**To:** File, Original Biological License Application (BLA) STN 125694/0

**From:** Wei Wang, CMC & Facility Reviewer, Lead Inspector, OCBQ/DMPQ/B1

**Subject:** DMPQ Review Memo for the BLA, STN 125694/0

**Product:** AVXS-101 (onasemnogene abeparvovec, ZOLGENSMA), general information:

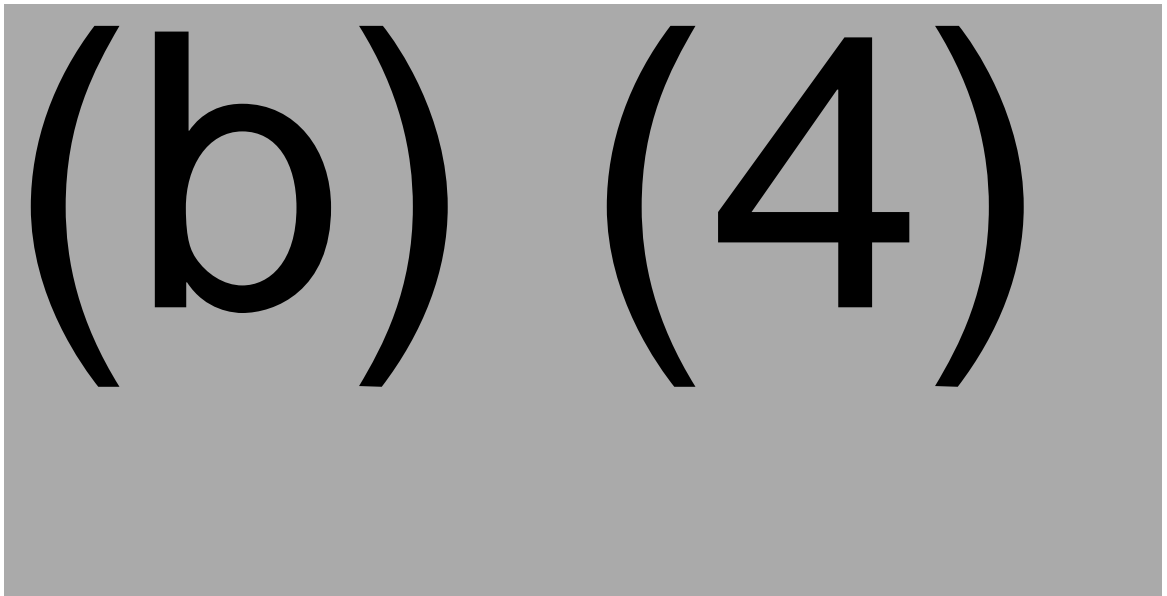
**Reviewer's Comments:** *Noted, in RPT-877 and RPT-883, the sponsor indicated that the carrier will replenish the shipper with (b) (4) every (b) (4). The sponsor's shipping validation data in the summary report RPT-921 was accepted.*
